Interference Between Exhaust Pipe U-Bolt and Sleeper Rail

M-252-004

(May 2008)

All Mack CXU, CHU sleeper chassis equipped a single exhaust and a Mack-Cap DPF built before April 2008.

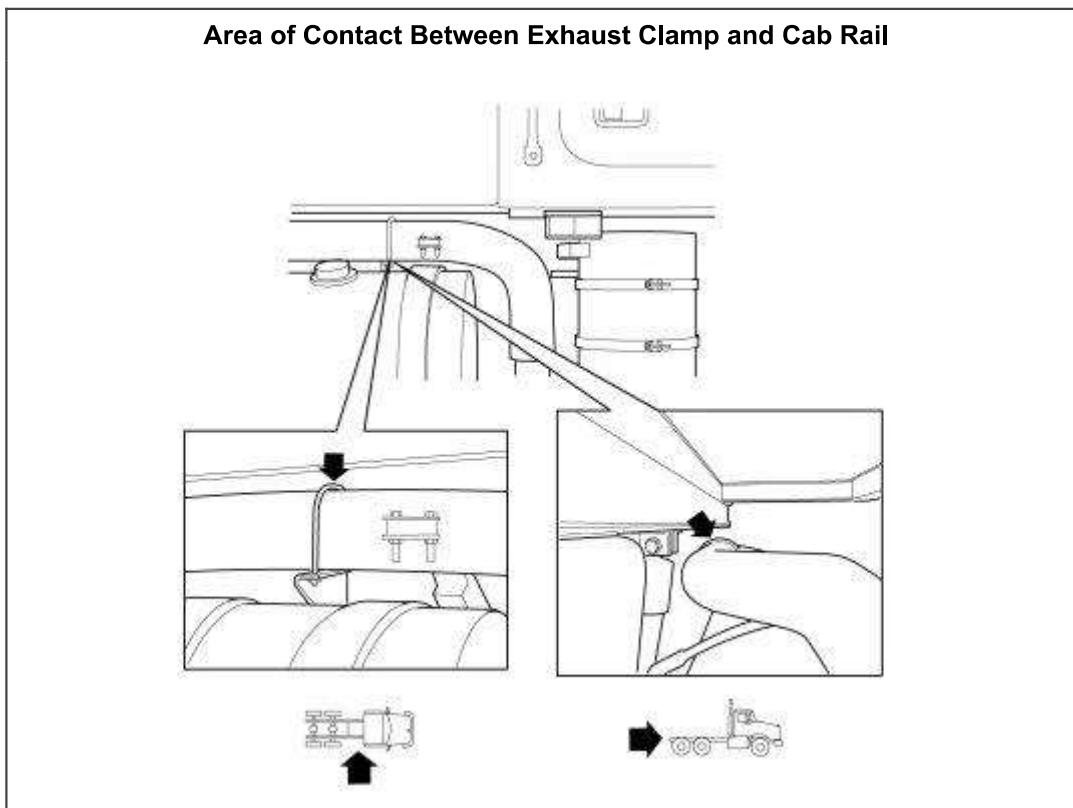
Effective April 21, 2008, a revised intermediate exhaust pipe and DPF outlet pipe was implemented into production on CXU and CHU sleeper chassis equipped with a single exhaust system and MACK-Cap Diesel Particulate Filter (DPF). This change was made to eliminate an interference condition between the intermediate pipe U-bolt and the right-hand side lower cab rail. The revision to these pipes routes the intermediate pipe inboard of the cab rail in the area where contact may occur. Should contact between the exhaust pipe U-bolt and cab rail be encountered on a chassis manufactured prior to April 21, 2008, replacement of the existing intermediate pipe and DPF outlet pipe with the components outlined in this bulletin is recommended.

Revised Intermediate Exhaust Pipe and Related Components

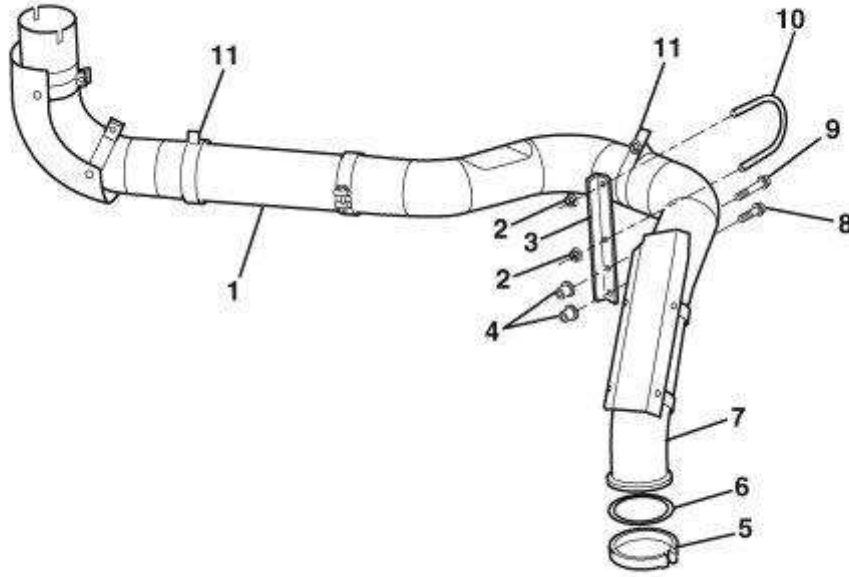
Parts required for installation of the revised intermediate exhaust pipe are as follows:

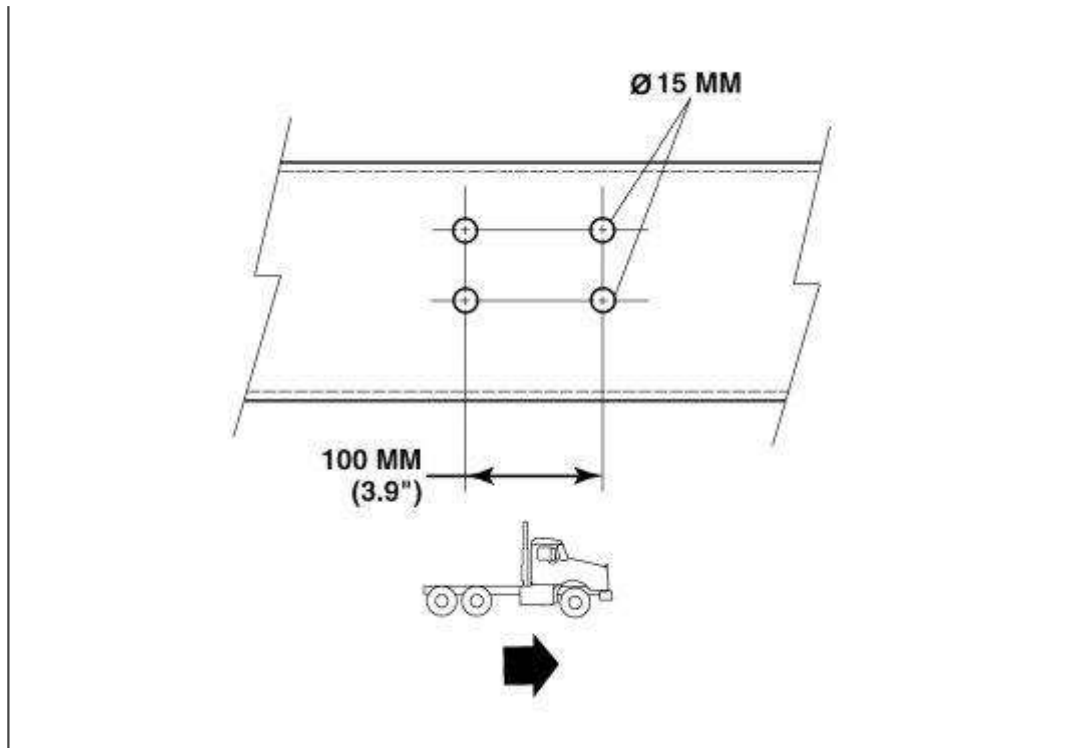
8. Mark and drill two 15 mm diameter holes in the frame rail, 100 mm (3.9") forward from the centerline of the existing U-bolt mounting holes.

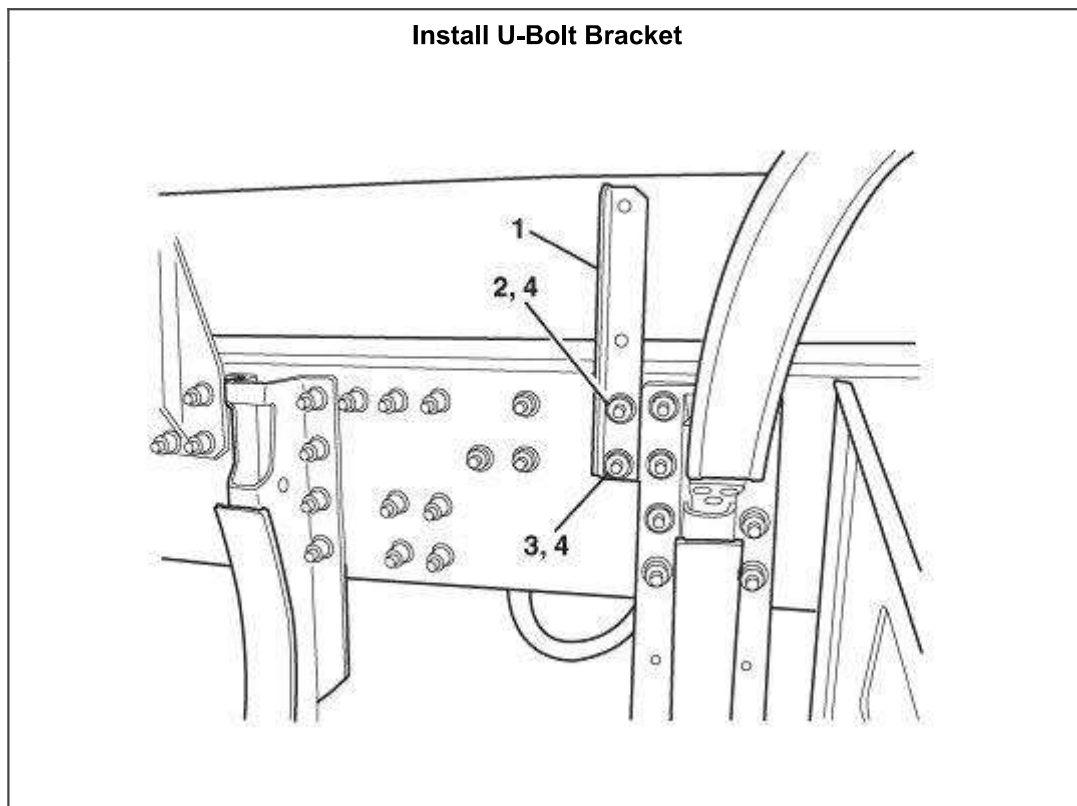
9. Install the replacement U-bolt bracket (part number 20492424) to the frame rail using two Huck-Spin® collars (part number 3187719), and pin part Nos. 3187721 in the upper mounting hole and 4AM34 in the lower mounting hole.

Note: Install two Huck-Spin® fasteners (pin part number 4AM34 and collar part number 3187719) in the two empty holes in the frame from where the previous U-bolt bracket was removed.
